ECN/PCN No.: R0516

Product Description: GSM Adhesive-Mount Blade Antenna	Abracon Part Number / Part Series: AEACCA115021-S850	☐ Documentation only ☒ ECN ☐ EOL ☐ Series ☐ Part Number
Affected Revision: IR	New Revision: A	Application: ☐ Safety ☒ Non-Safety

GSM Adhesive-Mount Blade Antenna

AEACCA115021-S850

Prior to Change:

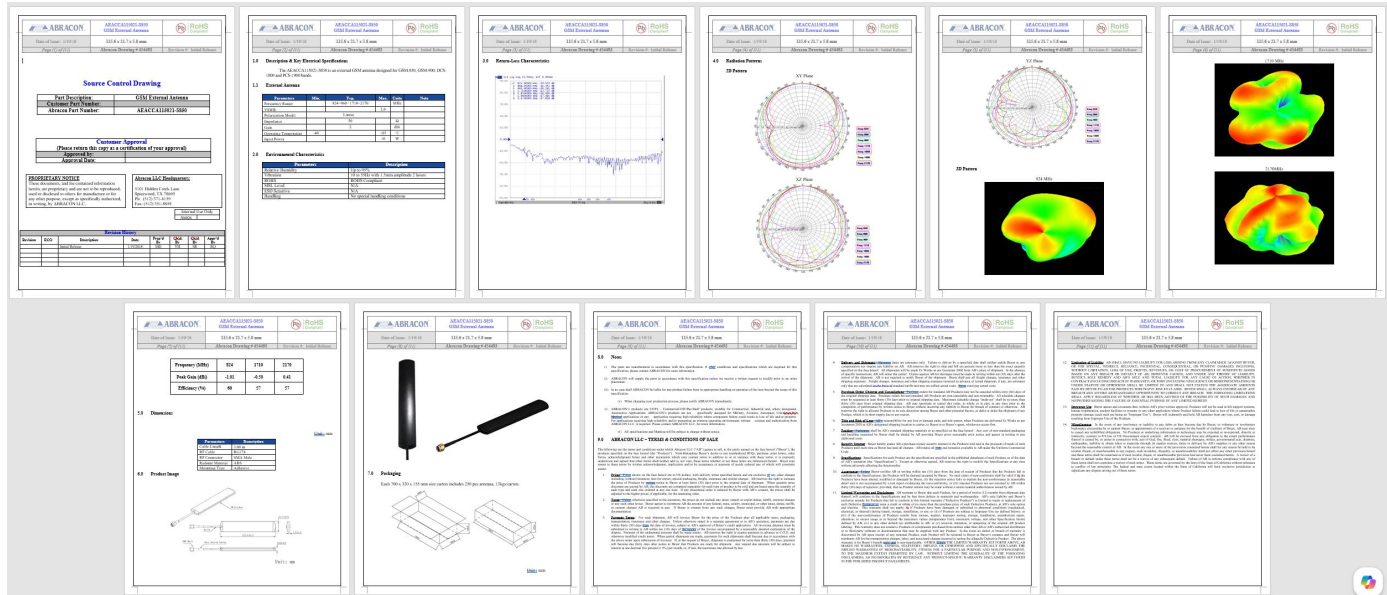
Cause/Reason for Change: Update document layout
